# Metropolitan Planning Commission

Staff Reports

September 14, 2010

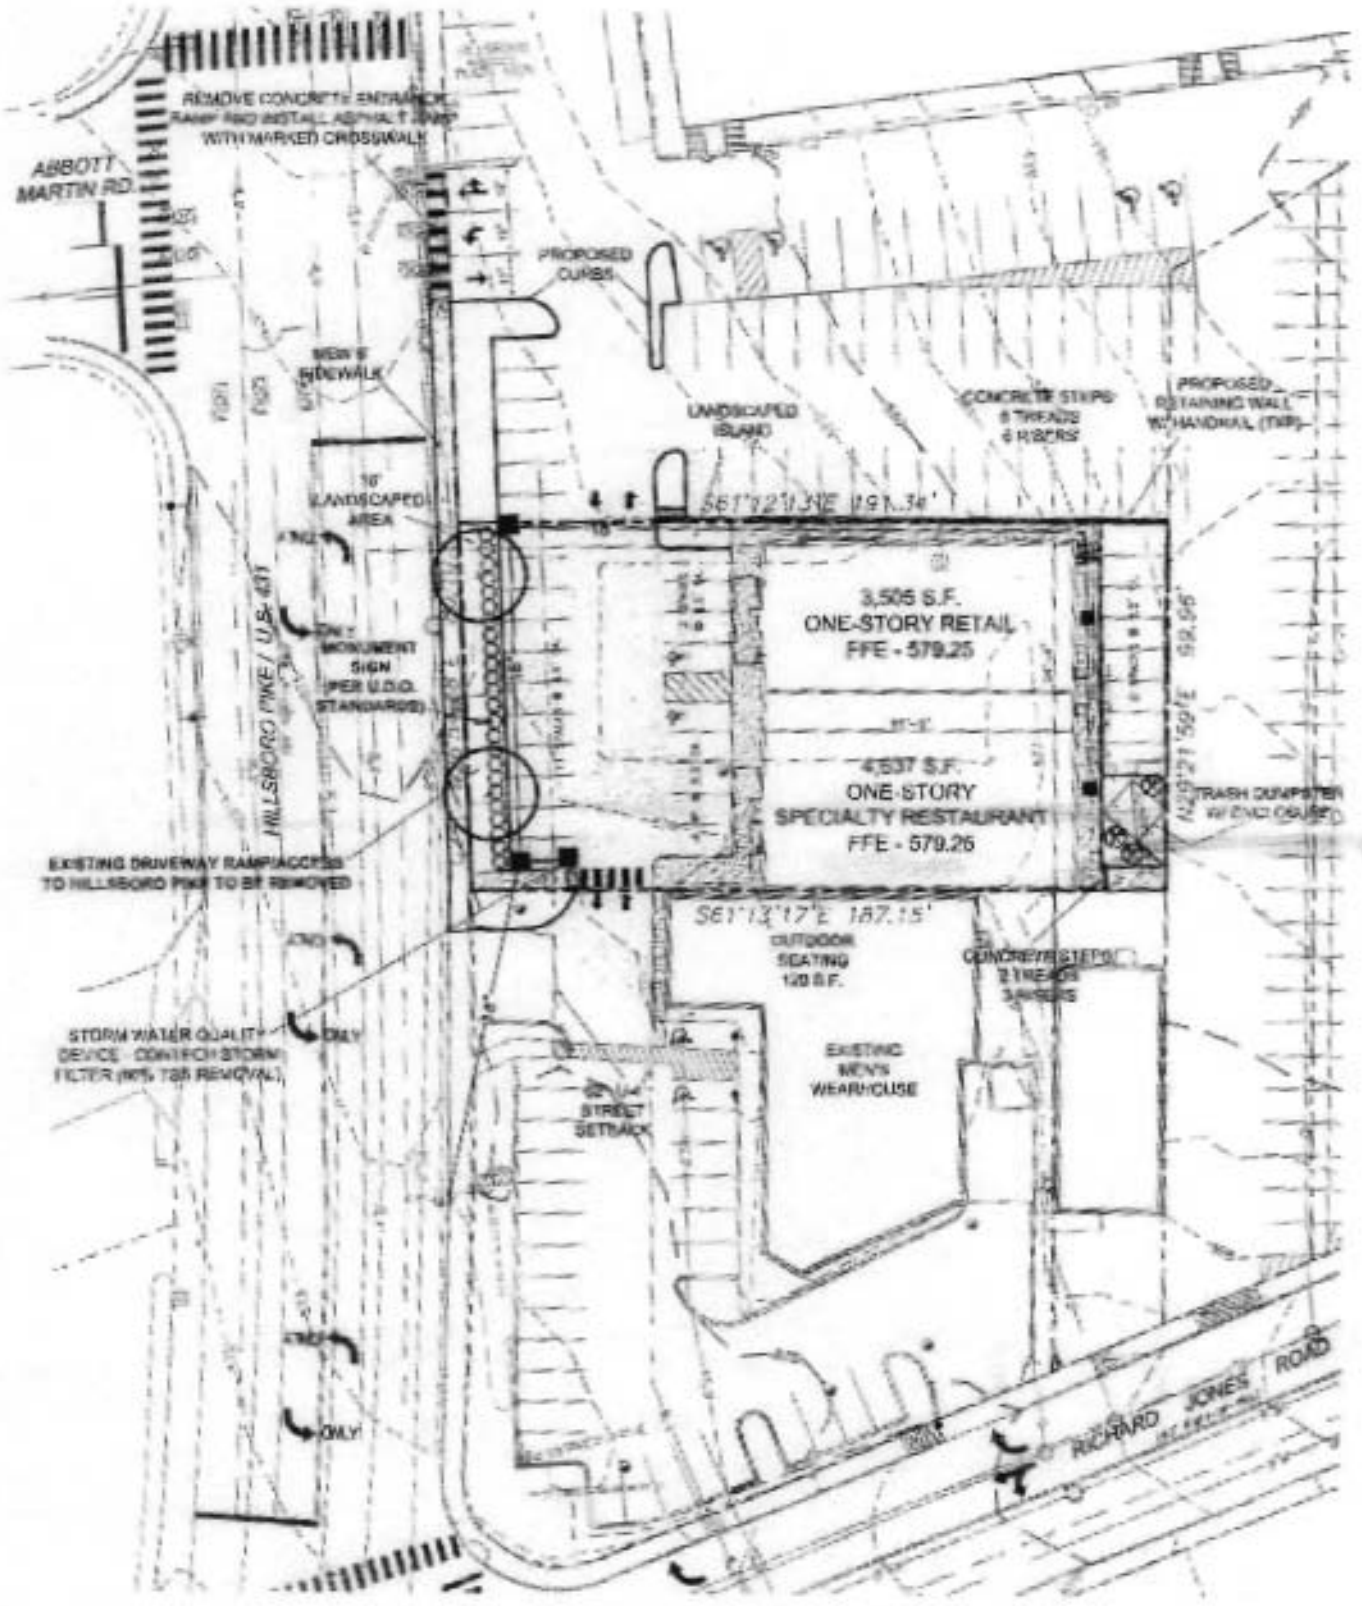
The proposed uses require sixty-six parking spaces under the Zoning Code. The plan only provides twenty-eight spaces. Zoning requirements for parking are as follows:

The proposed plan is significantly under parked. *Since it is so under parked and the applicant has not demonstrated any suitable parking alternatives, staff recommends that the request be disapproved.*

5. At signalized access to Hillsboro Road, remove existing concrete ramp and install asphalt ramp with marked crosswalk. Install pavement markings to delineate traffic and to provide 1 entering and 2 exiting lanes.

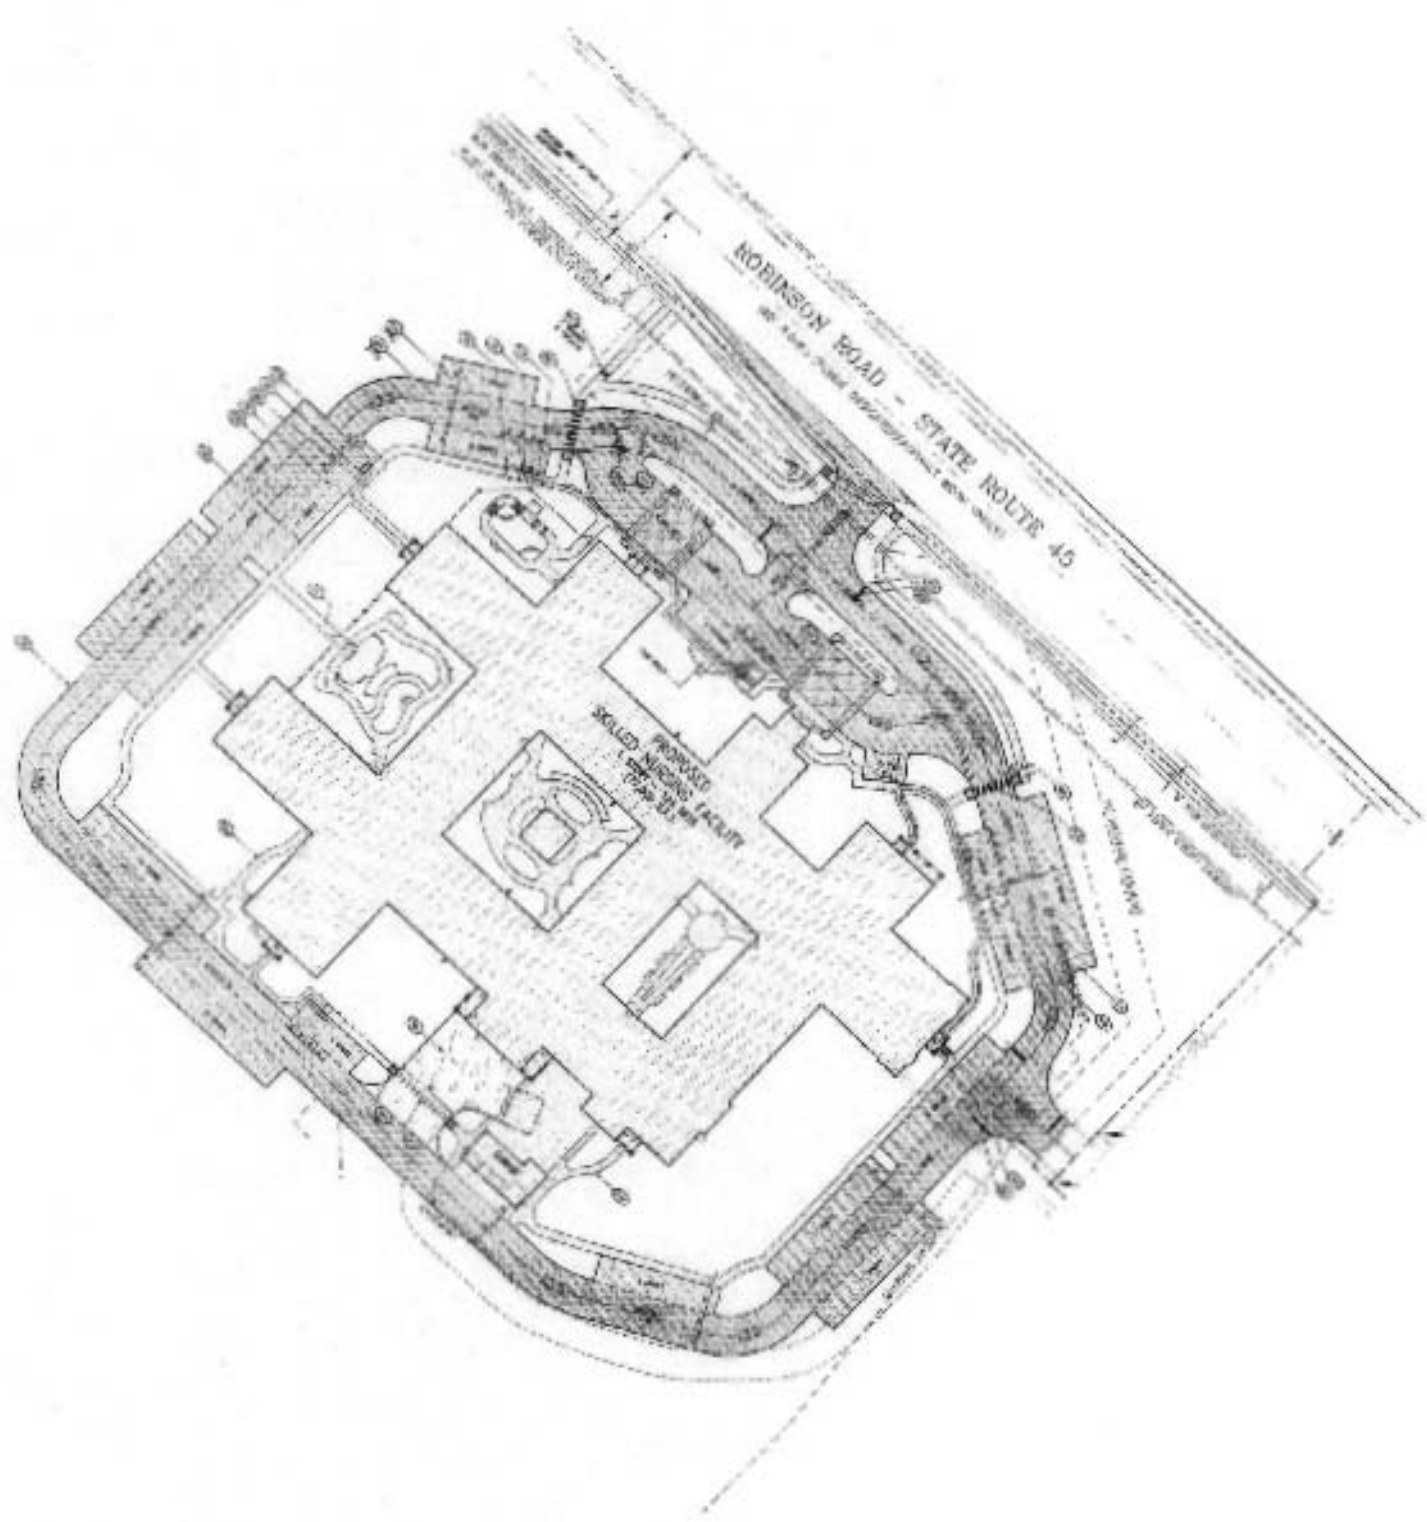
1. Provide Grading Permit fee (\$1425), Detention Agreement, and recording fees.
2. Provide NOC.
3. For the erosion controls, add outlet protection to all headwalls and use an inlet protection per our TCP's.

4. Add the following note to plans: "Contractor to provide an area for concrete wash down and equipment fueling in accordance with Metro CP - 10 and CP - 13, respectively. "Contractor to coordinate exact location with NPDES department during preconstruction meeting."

5. Change note 4 on Sheet C2.0 (Site Grading) to state that final stabilization shall be achieved no later than 14 days of final grading. Also, add note that all 3:1 slopes or greater shall be stabilized with matting. Specify type and add detail to plans.

6. Provide all civil details (our inlet protection, outlet protection, junction box, etc.).
7. For the storm structures, show how the roof drains tie into H1. For the storm structures, limit 15" pipes to runs of 50' or less.

8. Provide Tc calculations for the offsite basin. Also, use Tc = 5 minutes for all the small basins.
9. Provide a delineation showing all the green and paved areas.

10. For the pond outlet structure, add a note to the plans that state that the stone and fabric are temporary measures and will be removed once basin is stabilized. Which detail will be the permanent structure (detail 6 or 7)? One detail shows an invert of 433 and another at 432?

11. Site contains many outfalls (flow-splitter). Consider revising without the splitter (unit may contain an internal bypass).
12. Show that the water quality pond safely routes the 100-year event.

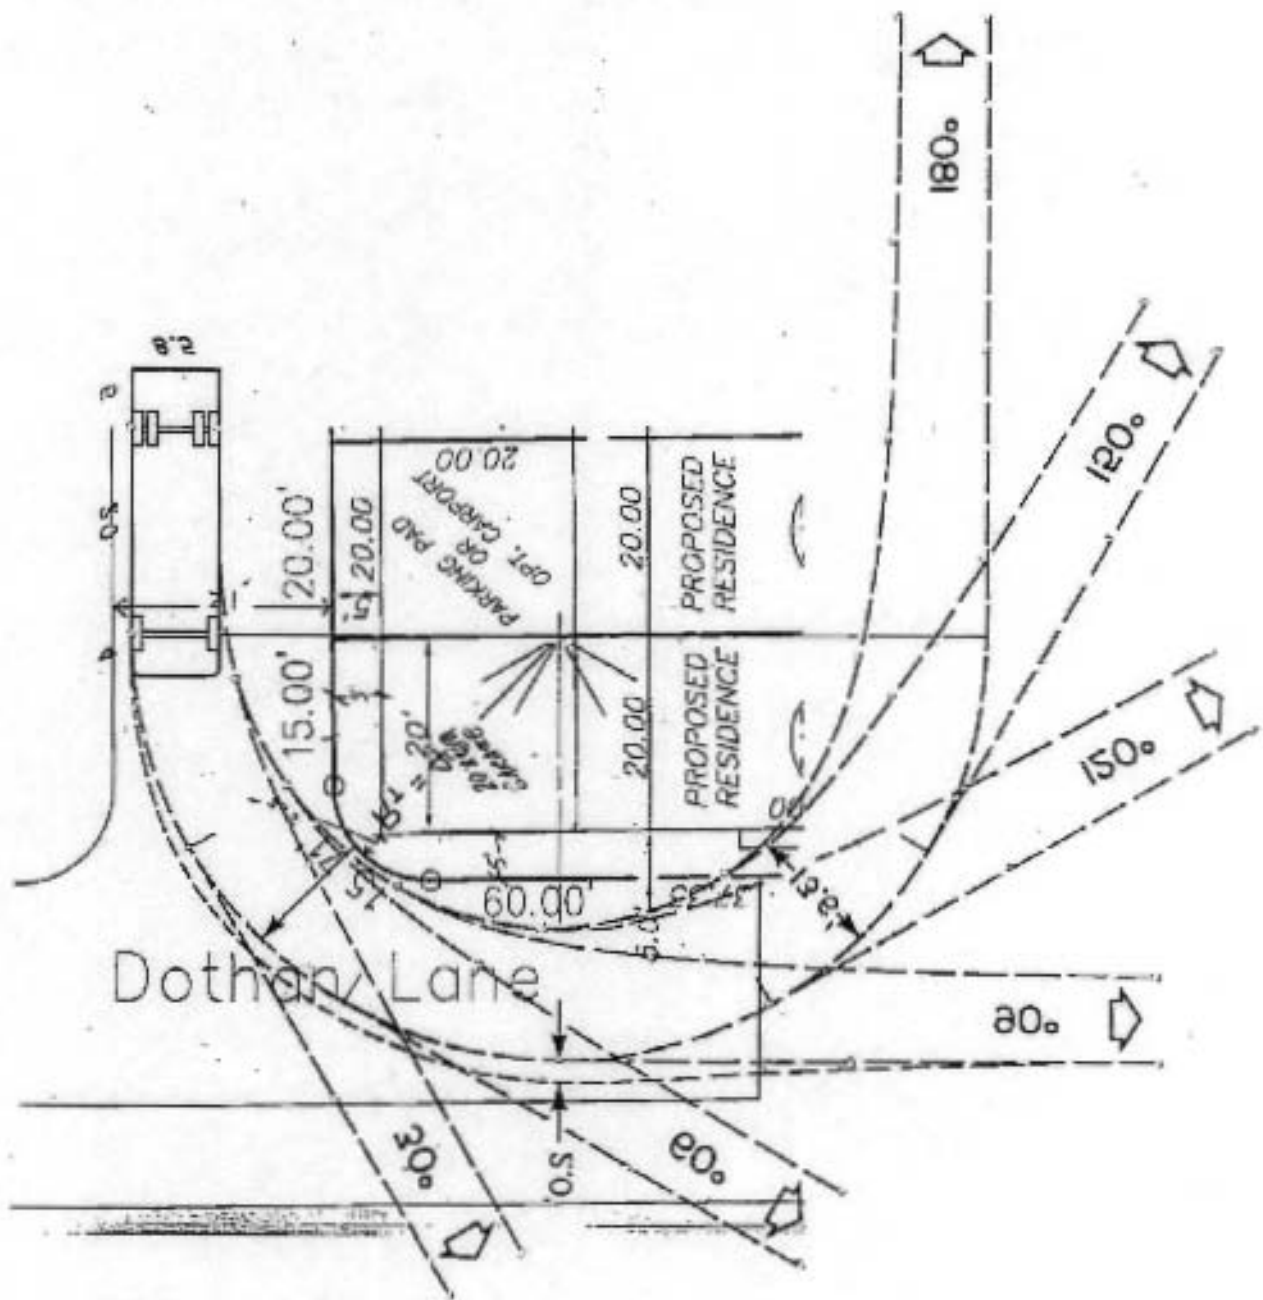
This setback amendment if approved will place the garage within 2.5 feet of the alley right-of-way at the corner, and three feet or less from the pavement. This portion of the alley serves as the turnaround for the weekly waste collection trucks and/or fire trucks that are typically SU-30 design vehicles. Turning templates indicate trucks will come very close to the garage with mirror overhangs potentially coming into contact with the garage unless a near perfect turn is made, creating a liability for both the homeowner and the driver (see graphic).
